SUNDRY NOTICES AND REPORTS ON WELLS

8. Well Name and No.
Skelly Unit # 9029. API Well No.
30-015-2932210. Field and Pool, or Exploratory Area
Fren, Wolfcamp11. County or Parish, State
Eddy County, New Mexico

RE: Convert to SWD – Conditions of Approval

Current Wellbore Diagram

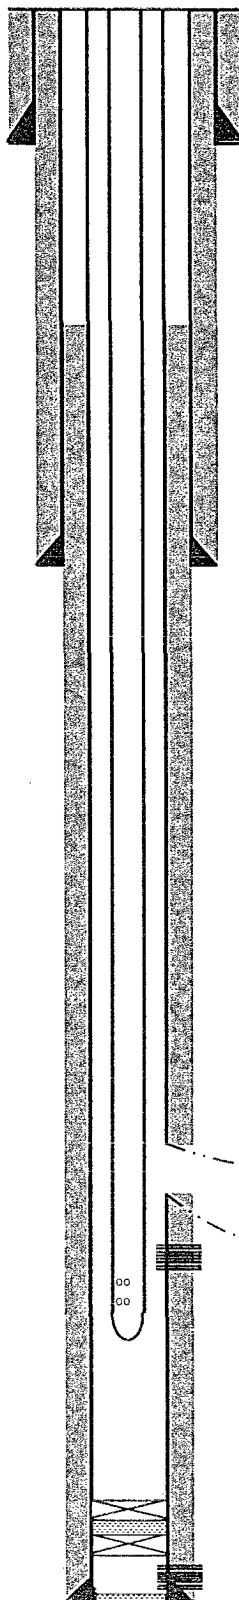
Prior to any further work being done, the well must be plugged back properly. The following plugs shall be set:

1. Spot 35sx of class H cement on top of CIBP at 11,870' (CIBP – Morrow top)

**Current
Wellbore Diagram**

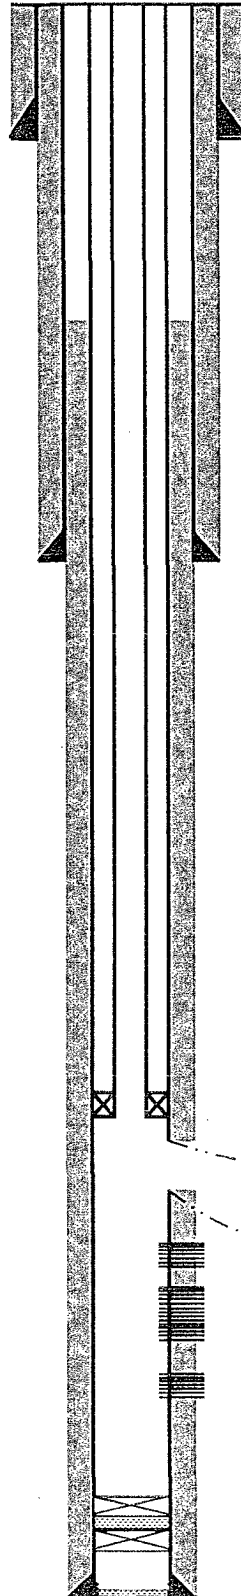
Perforations to be limited to the Wolfcamp – Bottom proposed set at 9766'-9661' may be in the Cisco formation.
